STAFF'S REQUEST ANALYSIS AND RECOMMENDATION

08PW0153

Colonial Heights Baptist Church (Colonial Heights Baptist Church)

REQUEST: Modifications to Development Standards.

PK-1

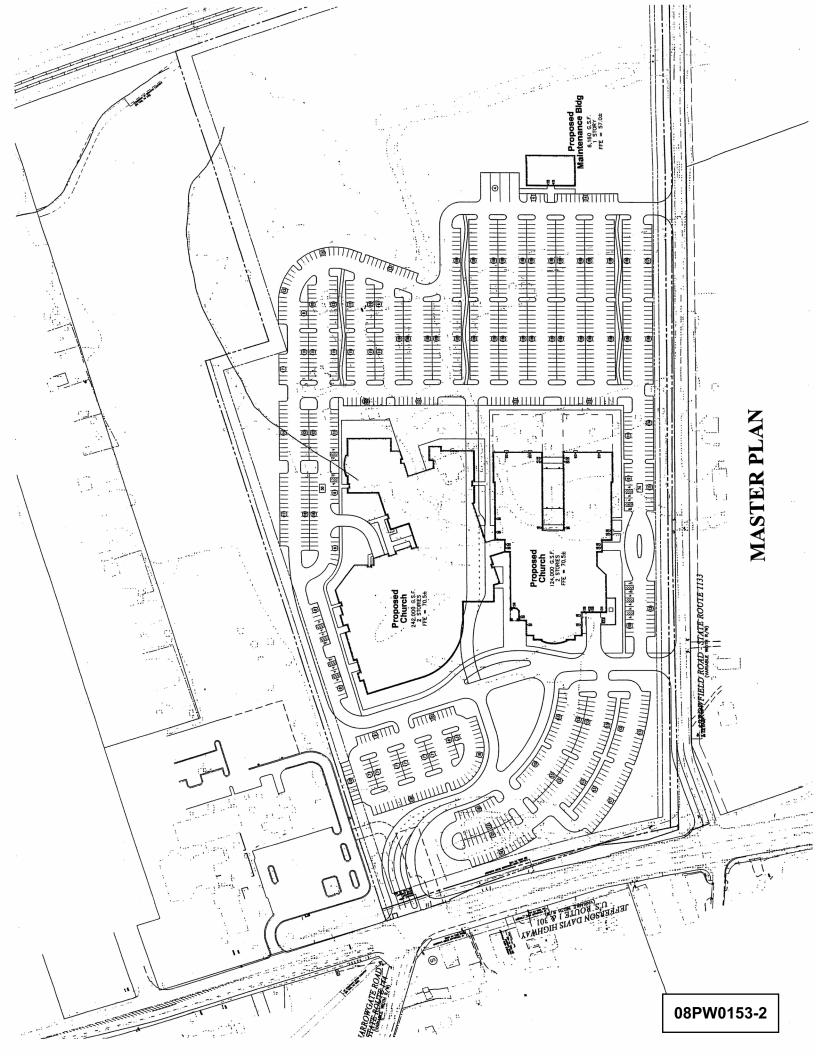
- 1. Runoff from Area B (gravel lot) shall be collected and conveyed in a non-erodible manner to an adequate outfall. (EE)
- 2. Provide revised drainage area calculations and make any required revisions to the stormwater drainage system. (EE)

- 3. Provide safety measures adjacent to the BMP. (P & EE)
- 4. Provide culverts and installation methods approved by Environmental Engineering Department and Fire and EMS. (EE & F)

- 5. Provide a detail of the gravel installation providing for a minimum of six (6) inches of stone for the gravel parking areas. (P)
- 6. Revise the plans to provide parking spaces that are at least 200 square feet and at least ten (10) feet wide in the gravel areas. (P)

- 7. Provide a method of delineating the parking bays and angle of parking in these gravel parking areas. (P)
- 8. Provide a method of delineating the perimeter of the parking and the entrance drives for Area B. (P)
